1. Are there any errors in the transcription of how to use Panasonic Coaxitron as shown in Appendix A, page A-1?

Fig.1-1 Command – response timing chart

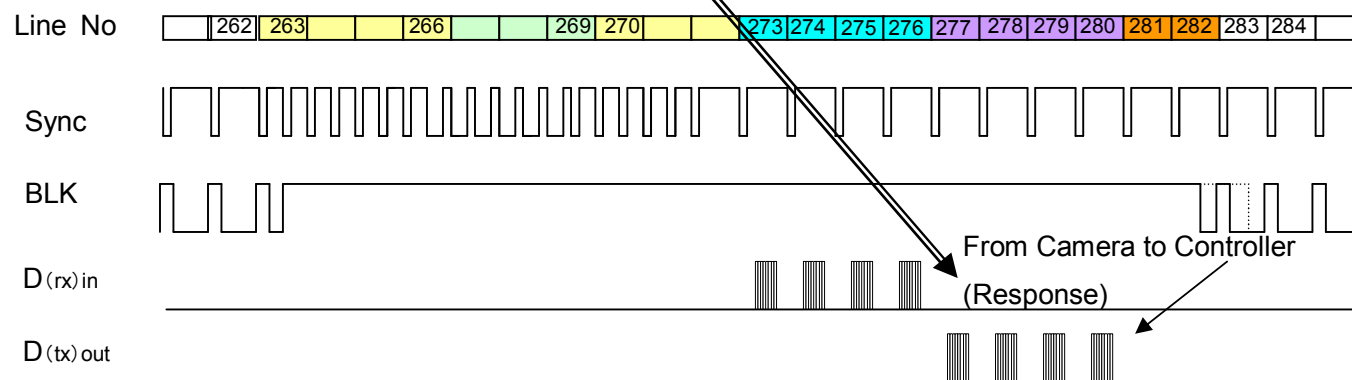
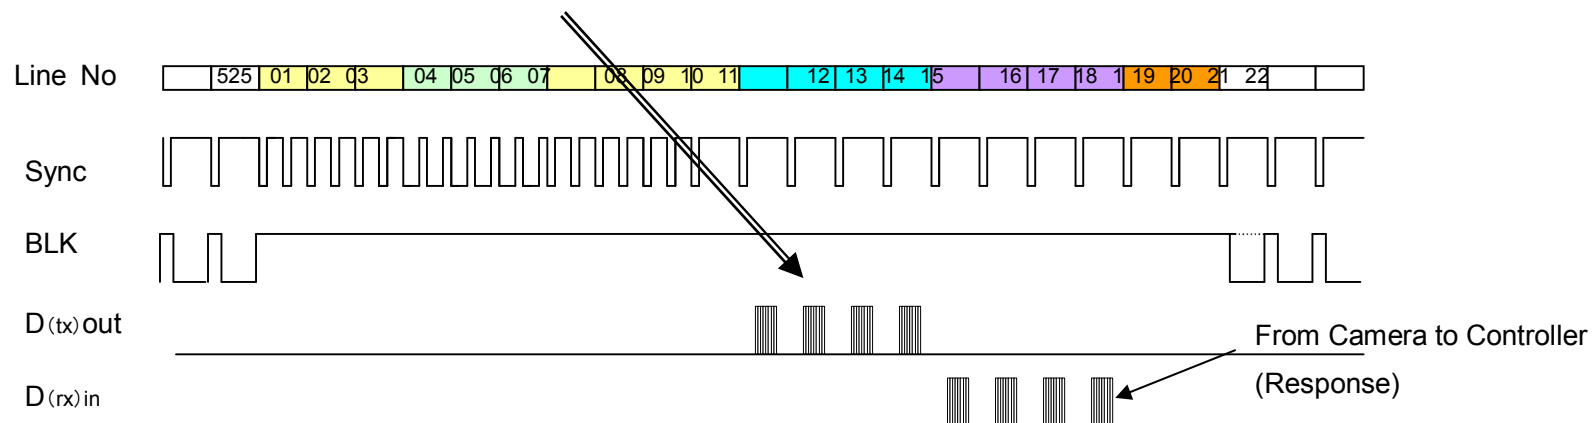
5. There is no indication of any timing requirements. I.e. for D Protocol, we specify that a command will be resent if there is no response within 250 ms. There is no equivalent for Panasonic. However there is a suggestion that all commands are synchronized with the vertical, or it might be horizontal, blanking timing. In one place there is a reference to an unrealistic 10 min, timeout.

Answer : after sending command, controller expects answer from camera in the next field. (for example, When controller data is sent on odd field (line 11 – 14), camera response should be on even field (line 277 – 280) right after the field which has head-end data.)

See Fig.1-1 and 1-2.

If there is no response in the next field, controller resend the command again in following field without gap. Controller resend up to 3 times (Total 3 times including first one).

Fig. 2 : Alarm bit horizontal timing chart

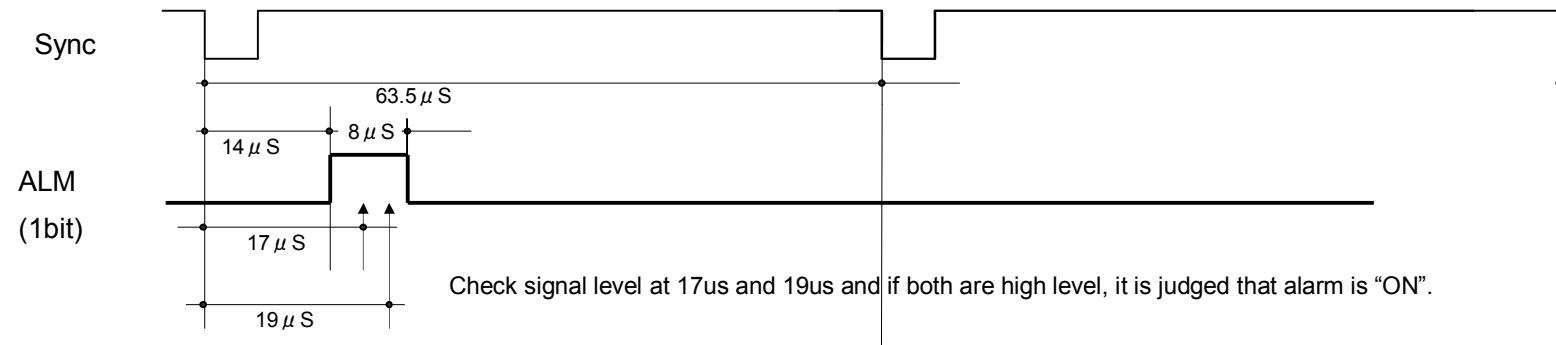
6.1. The format of "Alarm" data is not specified.

Answer: Alarm signal (1bit) appears in line 19 and 281 while camera is in alarm state.

See Fig.2 as horizontal timing chart.
